# Temperature sensors on APAs

IFIC-Valencia

# Introduction

# Problem 4: Misaligned holes in PCBs

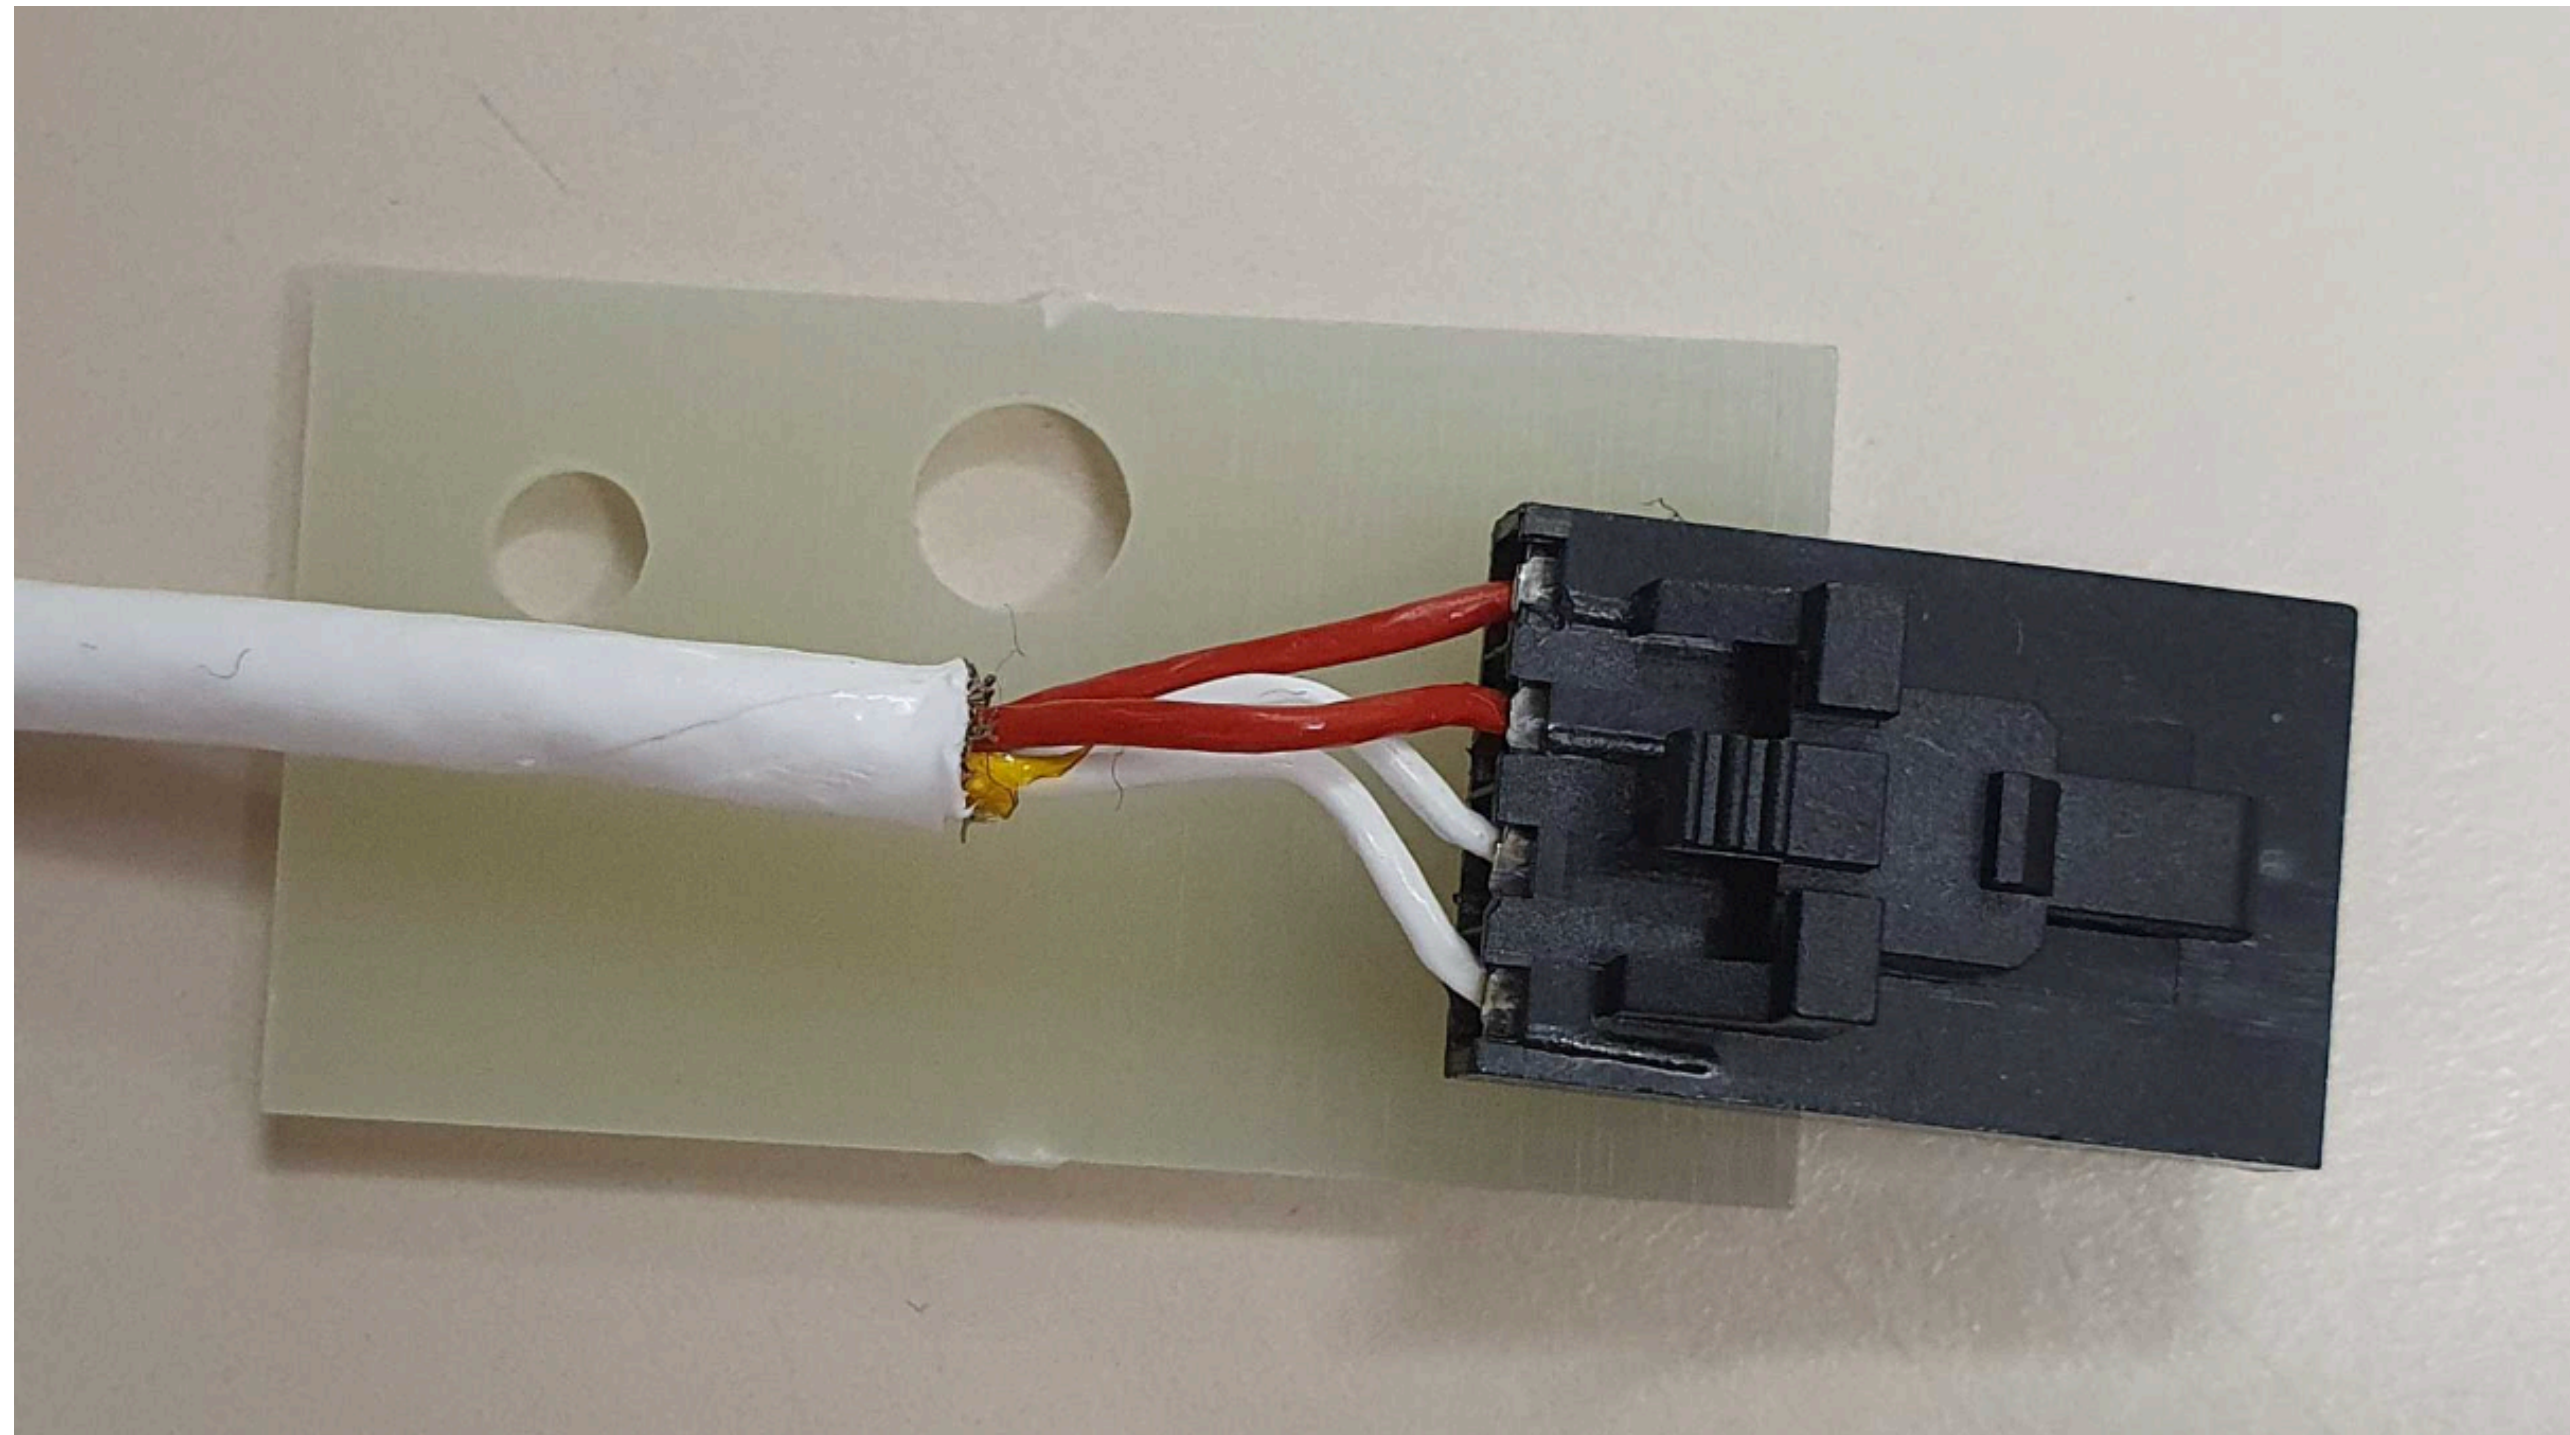
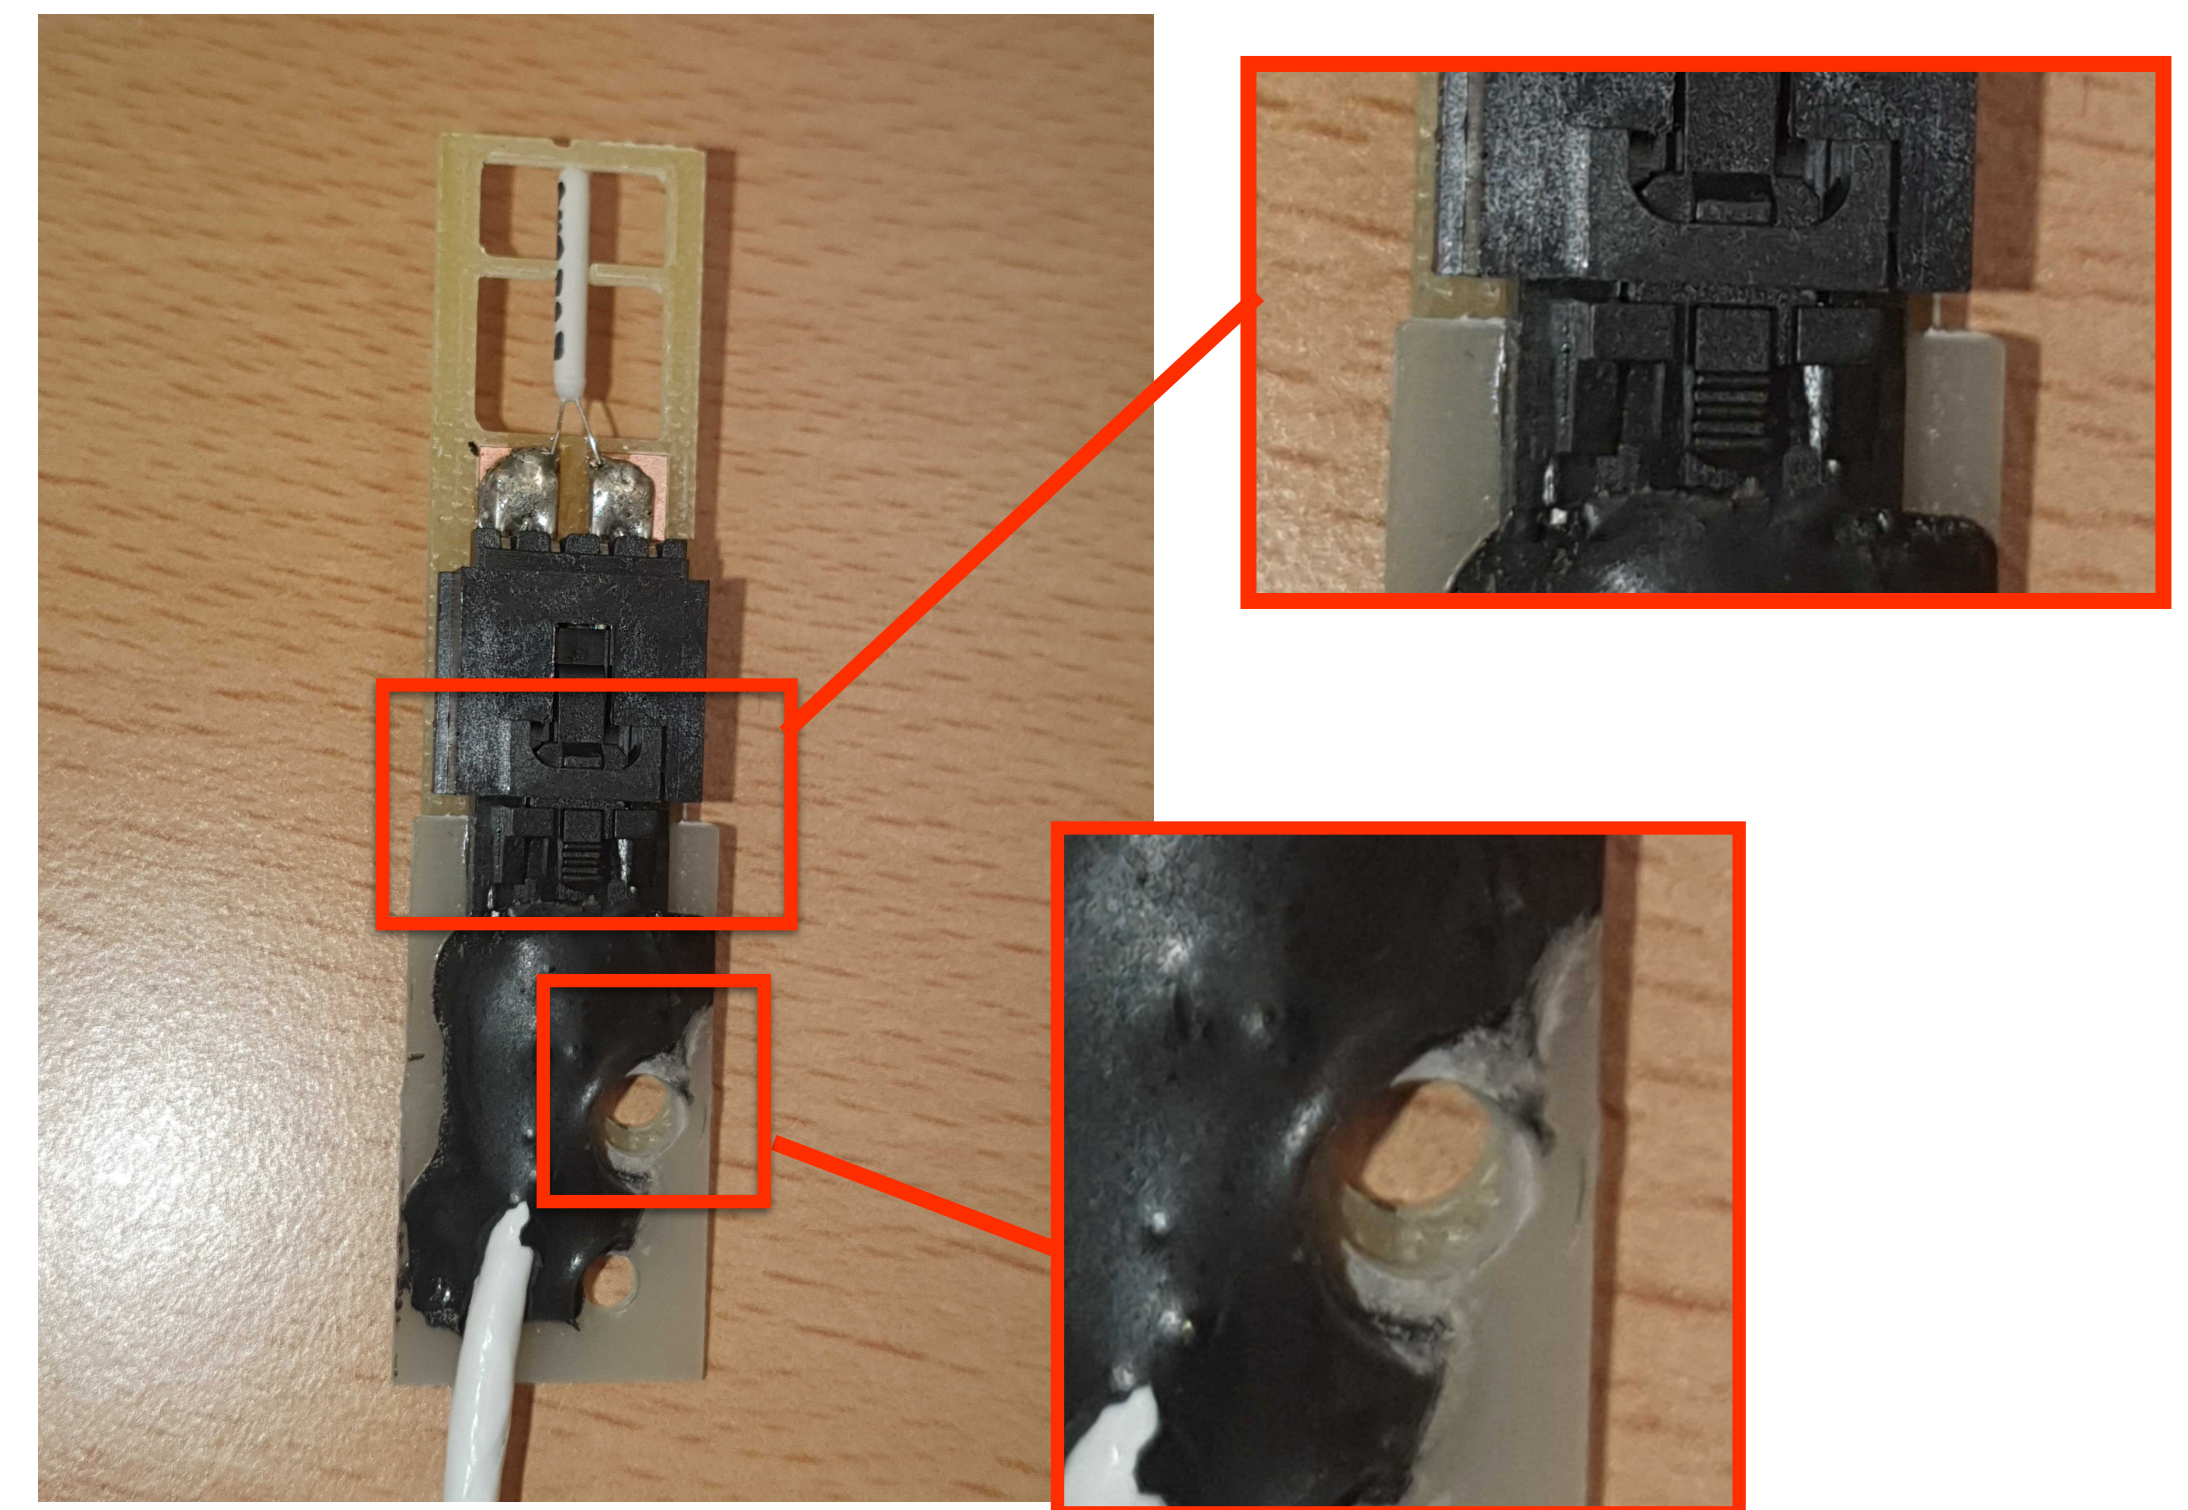
- The IDC-4 female connector is glued with loctite super glue-3 on the cable PCB. This is done manually, and alignment is done by eye

- In some cases the alignment is not correct and once the sensor is plugged in the holes of the two PCBs doesn't match each other

- **Repair:** Use a cylindrical lime to increase the size of hole in lower PCB
- **Changes in production:** A special tool where the cable PCB and the IDC-4 female connector are placed before gluing is been fabricated
- **Changes in QA/QC:** Mount the entire kit

# Problem 5: Sensor cannot be plugged in 9/60

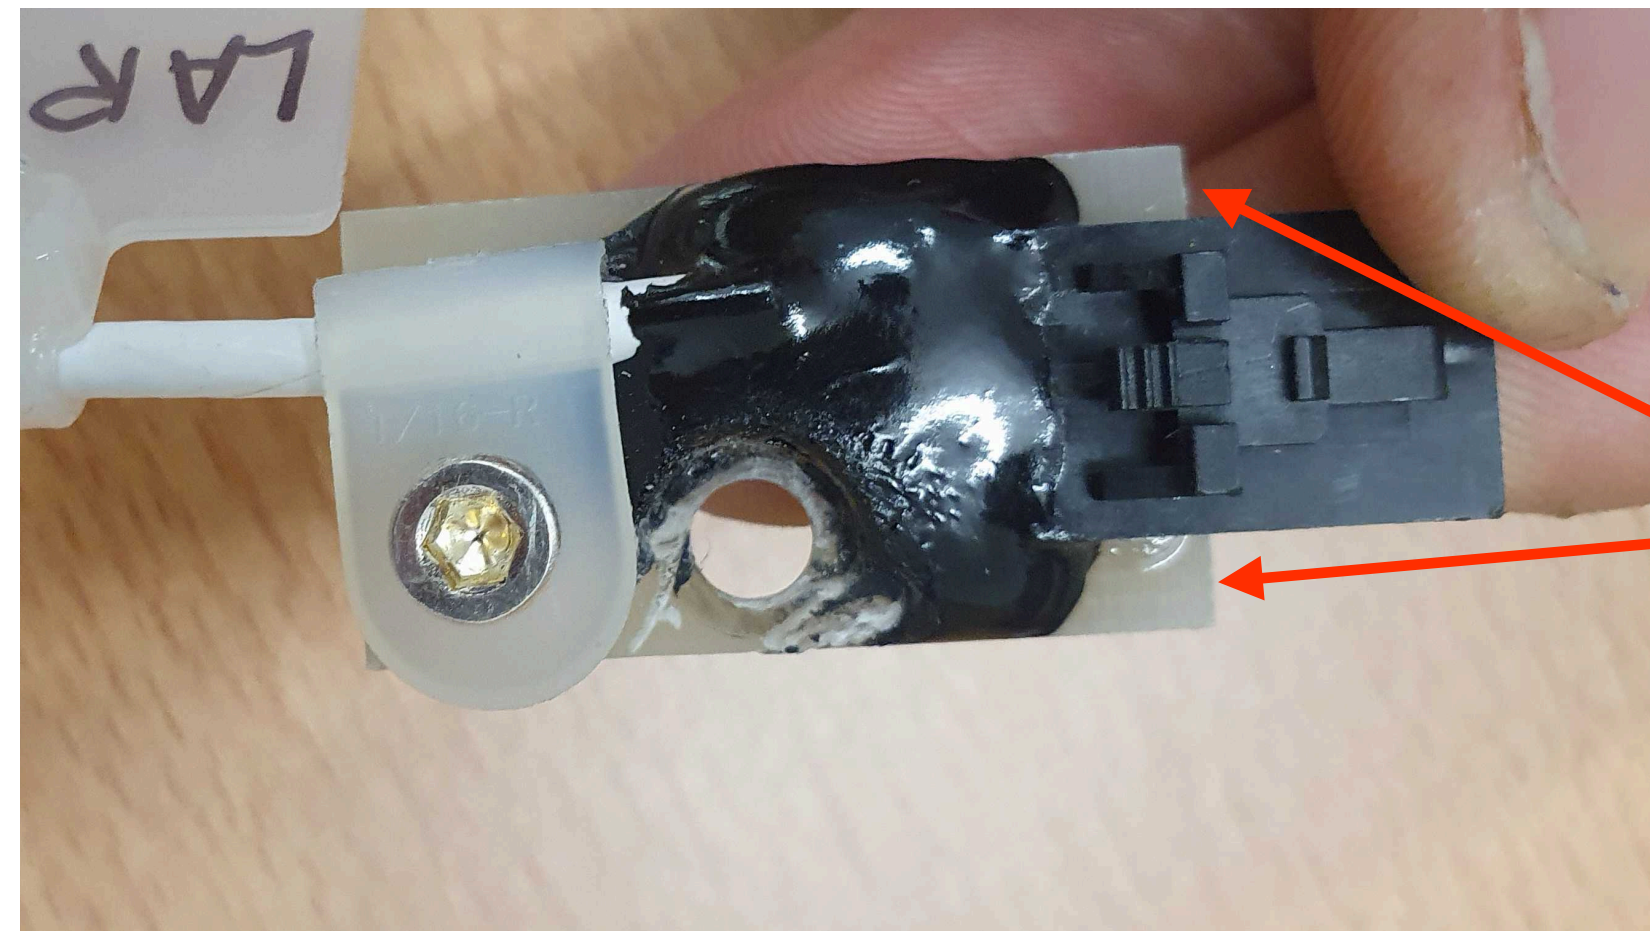
- In some cases the IDC-4 female connector is not correctly placed on the cable PCB (too much inside the PCB) and the sensor cannot be plugged in
- **Repair:** remove FR4 material with flat lime
- **Changes in production:** use new tool to correctly place the IDC-4 connector
- **Changes in QA/QC:** make sure RTD can be plugged in

Remove a bit of material in these two points

# Problem 6: Cable blocking M4 screw

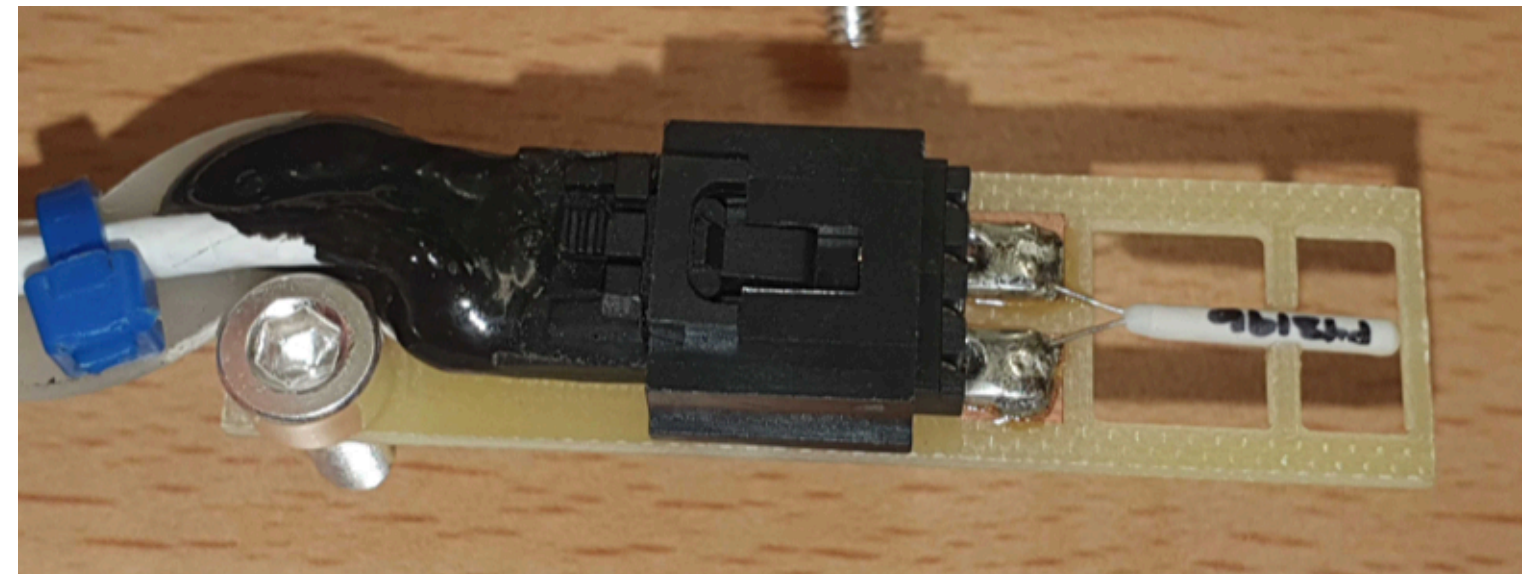
- For lower APAs there is no hole in the PCB. Instead a narrower PCB with the appropriate curve is used. Sometimes the cable prevents adding the M4 bolt
- **Repair:** There is no quick solution for this. The cable must be cut as close as possible to the edge and a new PCB and connector should be installed
- **Changes in production:** Correctly position the cable before epoxying. Add a bit of loctite super glue to fix the cable
- **Changes in QA/QC:** Mount entire kit with M4 bolt
